RE: **Lot 35 Block 6 Unit 2 SAD 227**
7904 Kibo NW
Volcano Cliffs Subdivision
Grading and Drainage Plan
Engineers Stamp Date 1/22/19 (E10D056)

DRAINAGE AND TRANSPORTATION INFORMATION SHEET (REV 6/2018)

RE: Lot 35, Block 6, Volcano Cliffs No. 2 Subd, SAD 227 (E10D056)
7904 Kibo dr NW

ENGINEER'S SEAL	Title: LOT 35, BLOCK 6, VOLCANO CLIFFS NO. 2	DRAWN BY
	CONCEPTUAL GRADING AND DRAINAGE PLAN	DATE
	RHD Engineering, LLC 4305 Purple Sage Ave. NW ALBUQUERQUE, NM 87120 (505) 288-1621	SHEET # X of X
	Richard Dourte P.E. #10854	JOB #

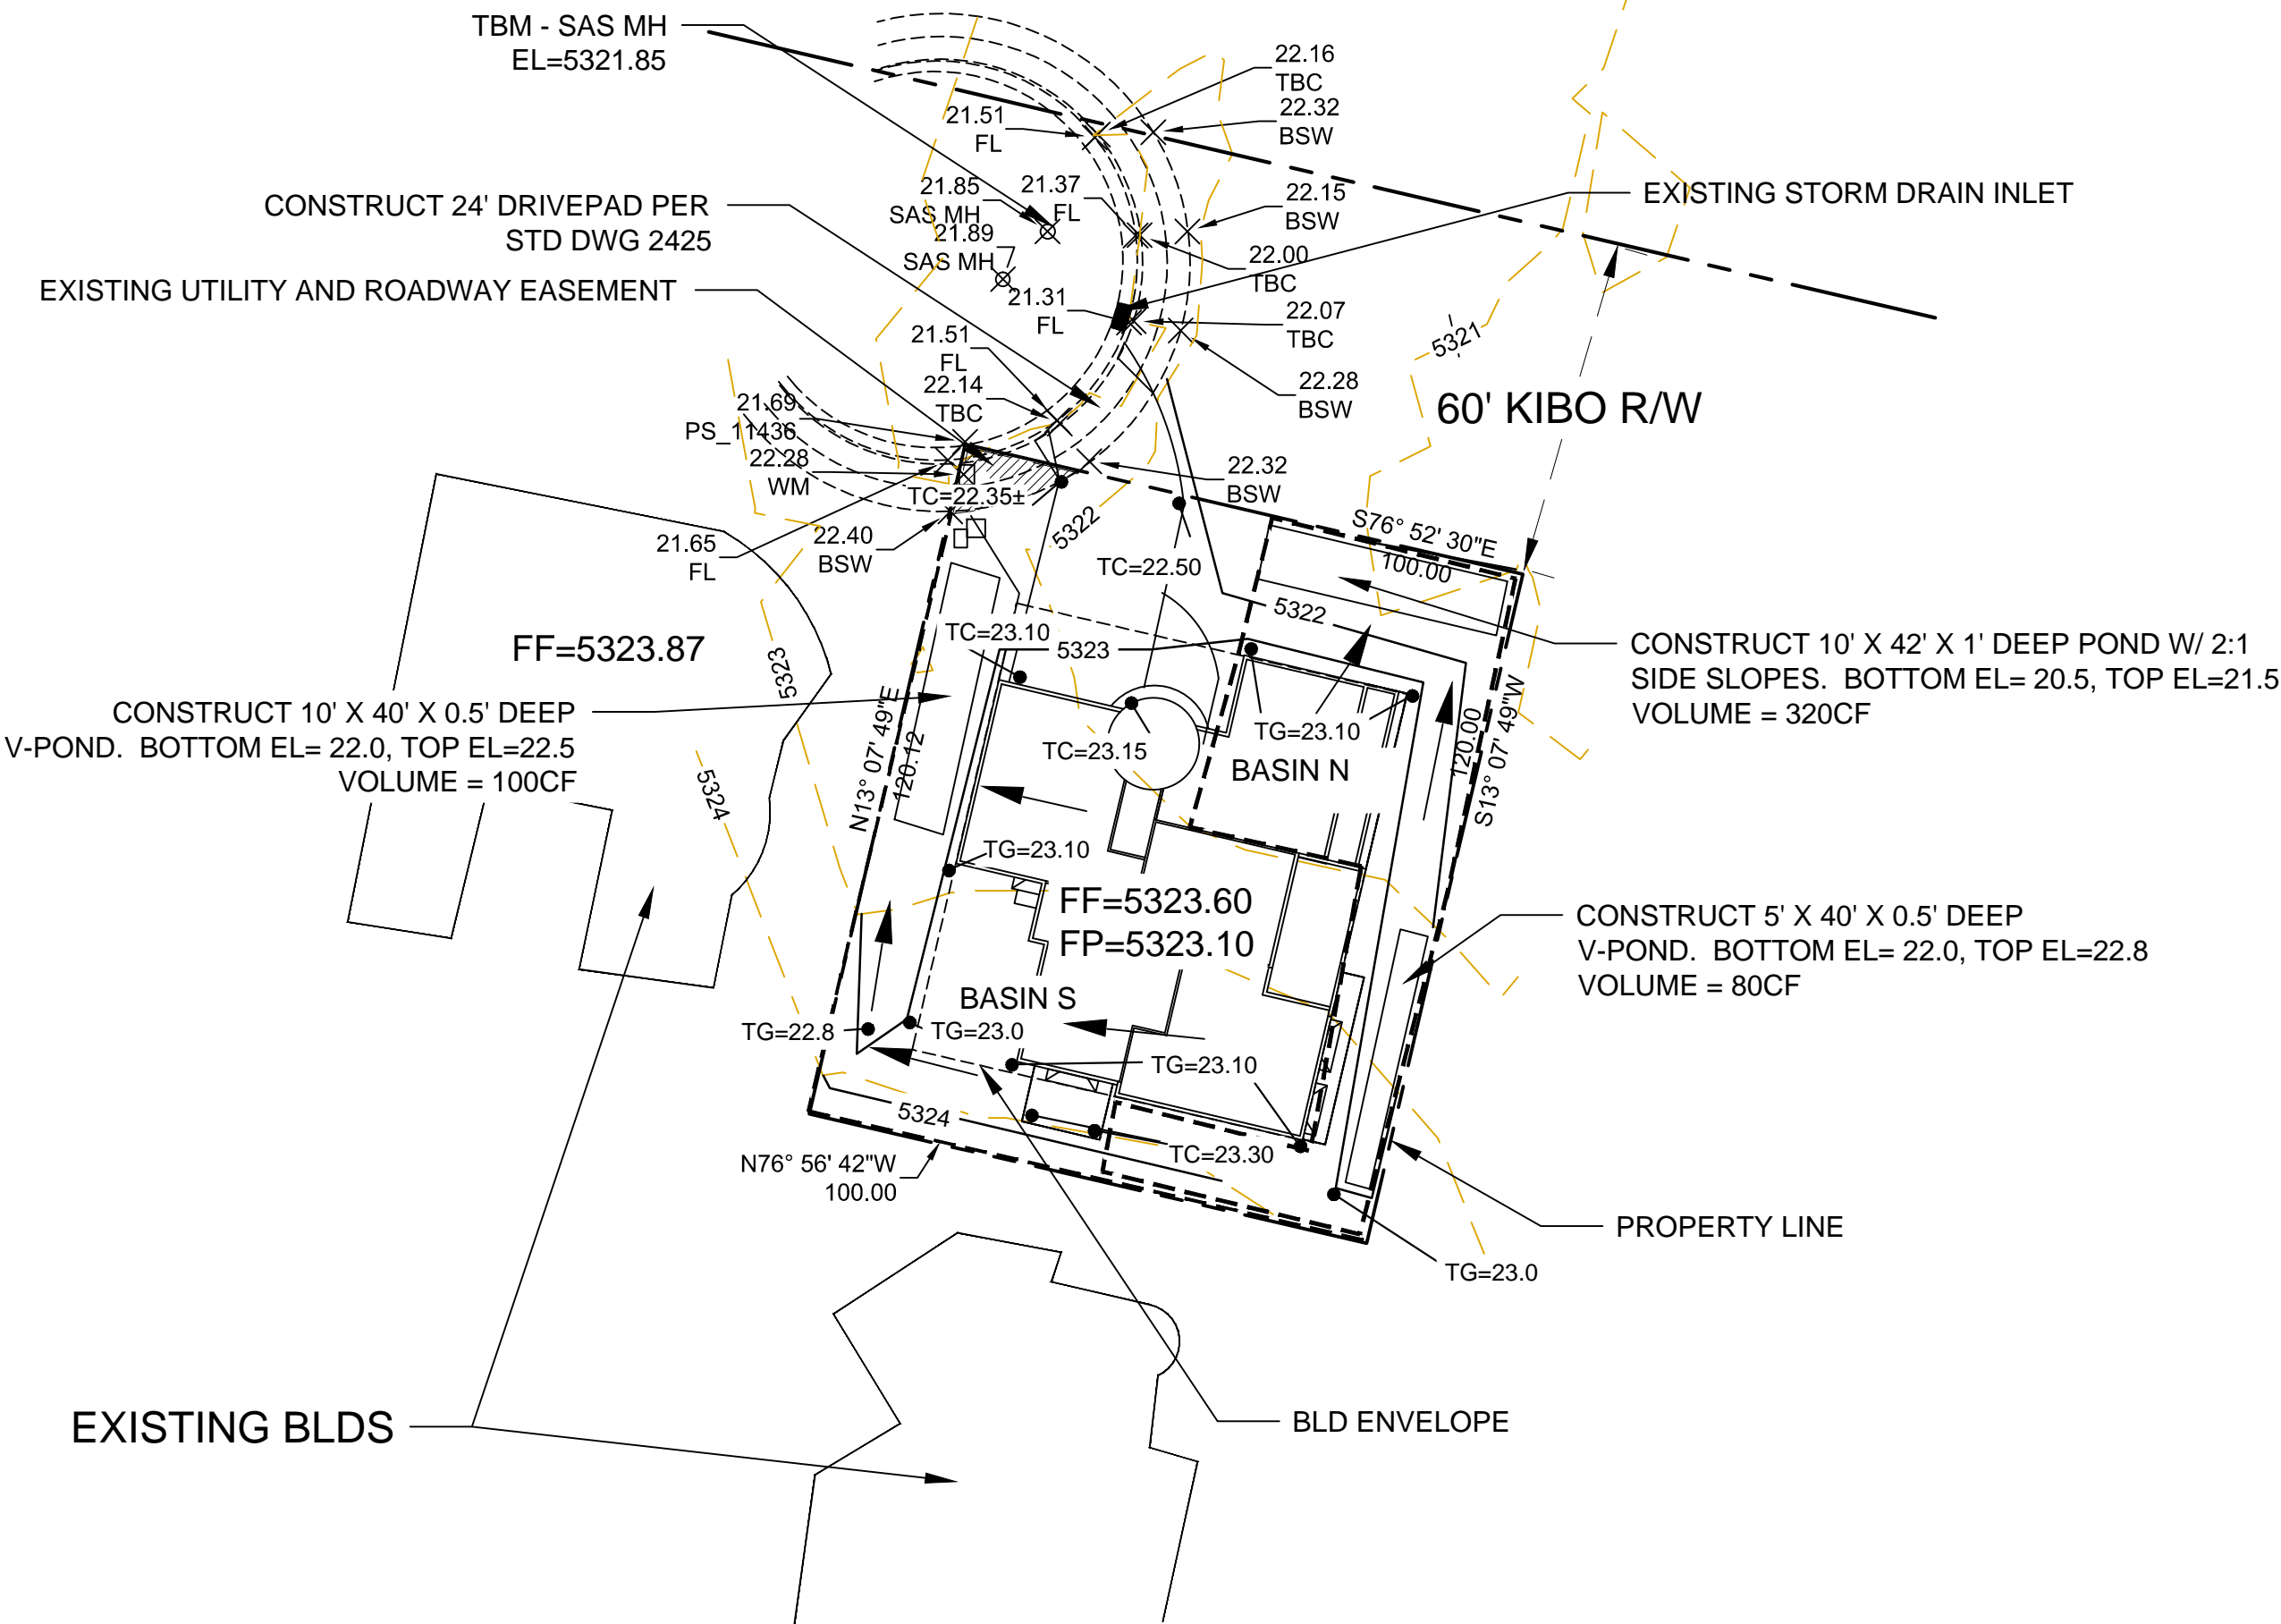
- Provide a section of the NE corner showing how the flows will drain to Kibo Ave. or a pond which will hold the 100 year 10 day volume.
- Provide the easement on the west side of the property.

- Provide a scale and the north arrow.
- Provide the property line for the entire site.
- The driveway appears to be entering the site through another property, clarify.
- Provide a benchmark.

1. A north arrow and scale was added.
2. The property line is called out.
3. The driveway goes thru the existing Kibo r/w, the original platting did not have a cul-de-sac at the location it presently does. The roadway easement for this cul-de-sac within this site has been shown.
4. A temporary bench mark has been shown (manhole in the street).
